Department of Energy

Enclosed is Change Notice No. 3 to DOE-STD-3009 that incorporates guidance on SACs. This revision was submitted for DOE-wide review and comment, and also was reviewed by and commented on by your staff. All comments are resolved. This revised standard was posted on the DOE Technical Standard Program website on March 24, 2006, and is available for use. Since DOE-STD-3011 references DOE-STD-3009 in all material respects when identifying and implementing SACs, we believe that no further revision to DOE-STD-3011 is necessary.

CHANGE NOTICE NO. 3
March 2006

Table of Changes

Figure 3-4. Flowchart for performing and accident analysis.

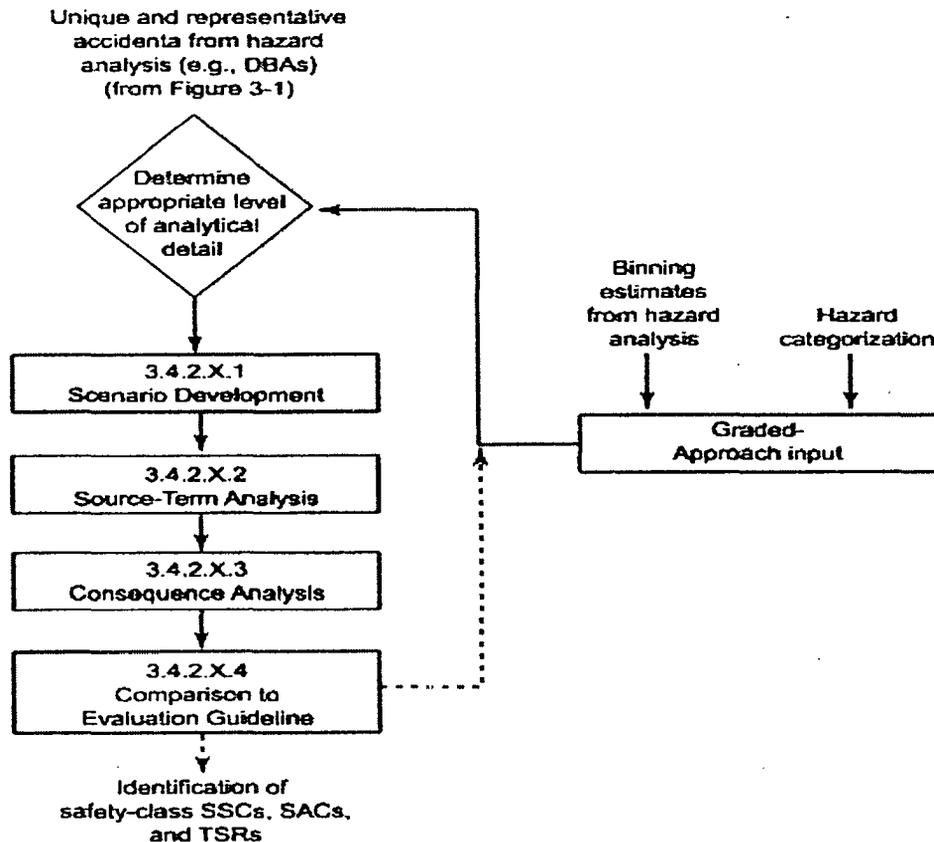
Chapter 3 section 3.4	Added "SACs" in third paragraph Revised Figure 3-4 to include SAC
Chapter 3 section 3.4.2.X.5	Added "SACs" to title of this section, and inserted "(or equivalent SAC)" in the first sentence of this section.
Chapter 4 Introduction	Revised to include SAC information.
Chapter 4 section 4.5	Added new section 4.5 Specific Administrative Controls
Chapter 5 Purpose	Added "(SACs)"
Chapter 5 Application of the Graded Approach	Added last paragraph to address SACs.
Chapter 5 section 5.3	Added "or SACs" in three places.
Chapter 5 section 5.5.X.3	Added last sentence in the section regarding SACs
